File Number	PLVAR-2510-0013		Contact	Christian Huelsman, chuelsman@duluthmn.gov	
Type	Variance from Shoreland Setbacks		Planning Commission Date		November 12, 2025
Deadline for Action	Application Date		October 8, 2025	60 Days	December 7, 2025
	Date Extension Letter Mailed		October 30, 2025	120 Days	February 5, 2026
Location of Subject		800 Railroad St			
Applicant	Donald Holm Construction		Contact	Max Holm	
Agent			Contact		
Legal Description		010-0200-01100			
Site Visit Date		October 29, 2025	Sign Notice Date		October 28, 2025
Neighbor Letter Date		October 22, 2025	Number of Letters Sent		3

Variance to Shoreland Regulations
800 Railroad St

PIER B HOTEL

SHEET TITLE	SPA EXPANSION
LANDSCAPE PLAN	
DATE	10/23/2025
DRAWN BY	AMA
CHECKED BY	LWS
PROJECT NUMBER	21001
SHEET NUMBER	11.0

A STORMWATER INTENTION PLAN
SCALE: 1" = 5'

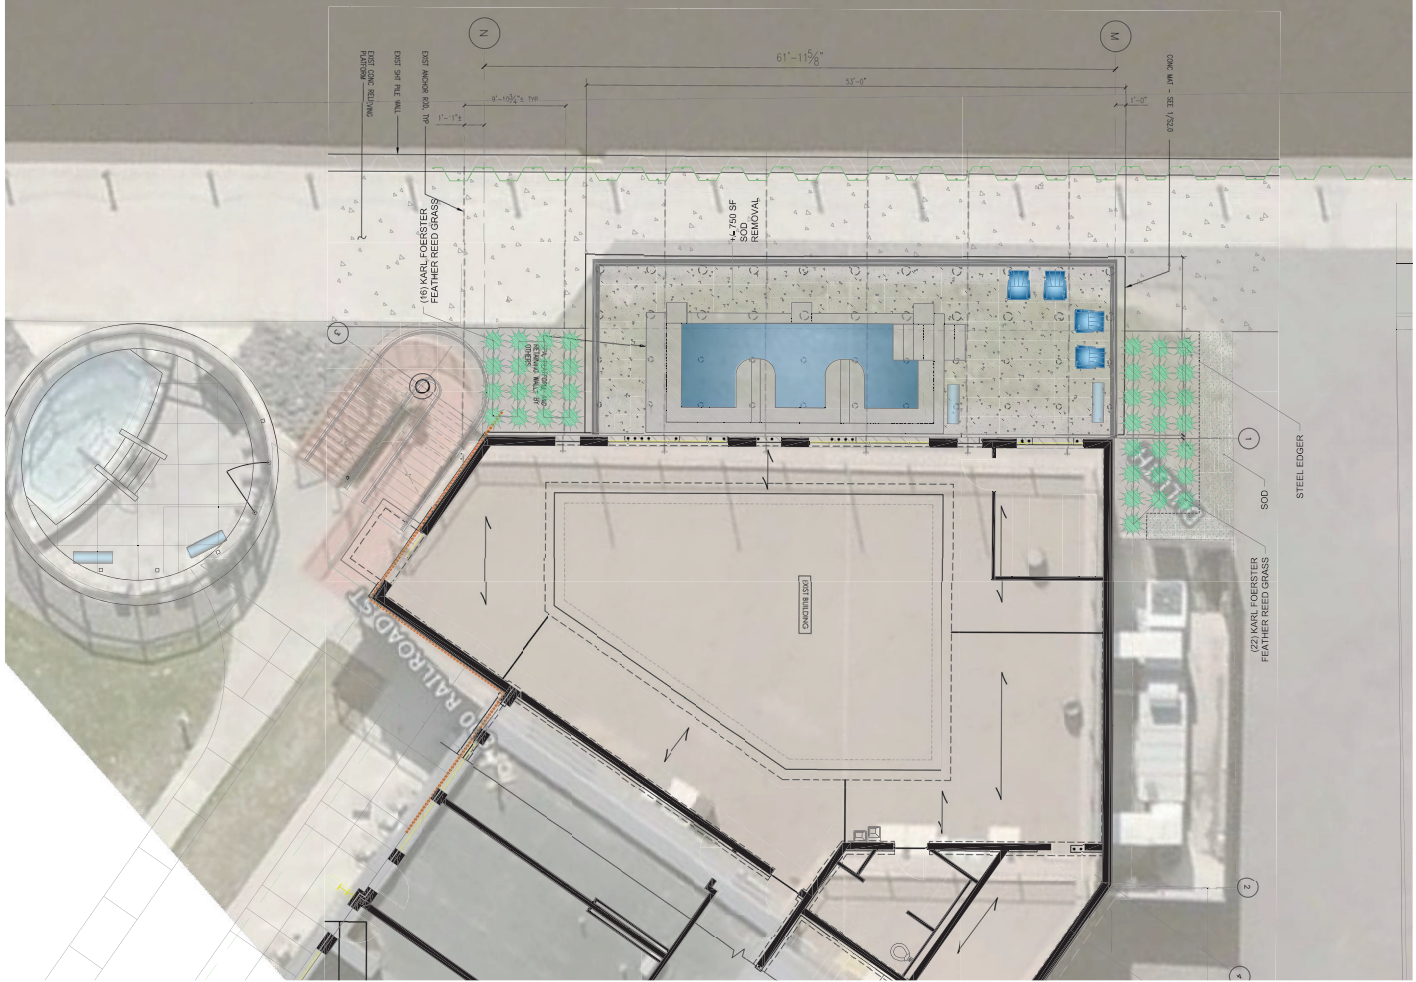
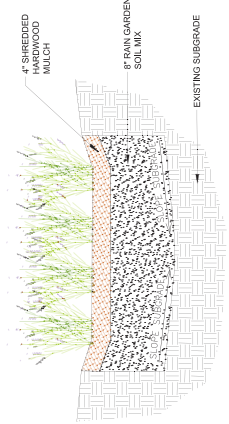
- 9) *Standards for variances in shorelands*
The applicant has submitted details to mitigate the impacts to shorelands from the addition of impervious. Runoff from this site runs downhill away from the exterior spa deck, into drain tile and daylights, through the elevated wall to infiltrate to the planting area to the east and west. Staff recommend that any approval of this variance be conditioned such that a mitigation plan with native plantings in the rain gardens, designated to infiltrate water from the proposed deck, is submitted to the Land Use Supervisor prior to approval of a building permit.

While there is existing seawall, there is already very limited vegetation on this lot and this deck will reduce that. Have they proposed mitigation for adding additional impervious surface within the shore impact zone?
